**KNOXVILLE HISTORIC ZONING COMMISSION
STAFF REPORT - CERTIFICATE OF APPROPRIATENESS APPLICATION**

MEETING DATE: 2/21/2008 ▶ FILE NO.: 11608FEM

ADDRESS OF PROPERTY: 2016 Fairmont

▶ DESCRIPTION OF WORK: Construct new front porch, 30' wide, 8' deep: roof slope 2/12, shingled, wood banister at front edge approximately 24" high with square 4"x4" posts and 2" ballusters set into top and bottom rail; 6"x6" square wood columns, exposed concrete block foundation with 4" concrete slab floor, concrete steps.

2016 Fairmont Blvd
Knoxville TN 37917

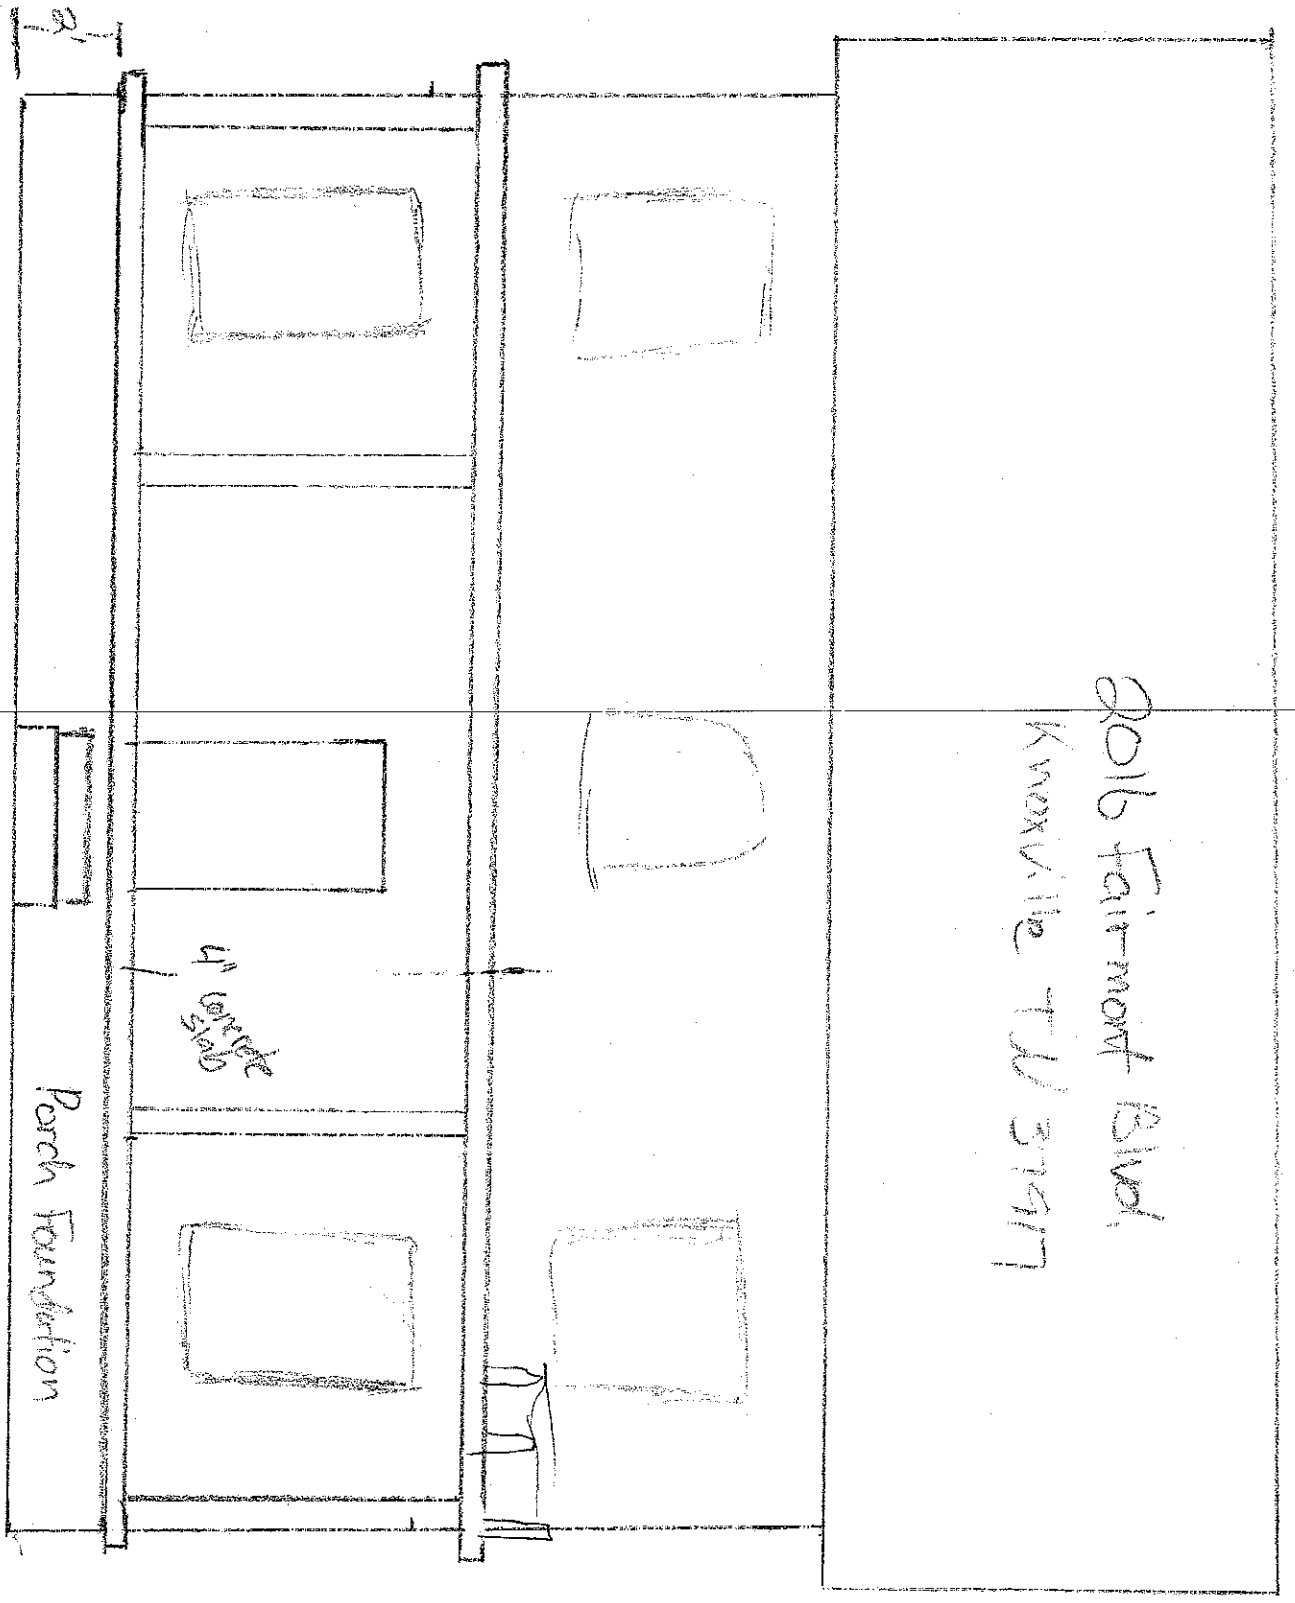
DENY Certificate No 11608FEM without prejudice. Submitted drawing does not contain details adequate to assess impact of change of porch design on front elevation of building.

The Fairmont Park design guidelines suggest that porticos are more appropriate for two story Colonial Revival dwellings. Those porticos should be gabled with arched ceilings or broken pediments. As a second alternative full and half porches may be considered. Porch trim includes columns with elaborate capitals and turned or sawn wood balustrades. (pg. 6, Design Guidelines)
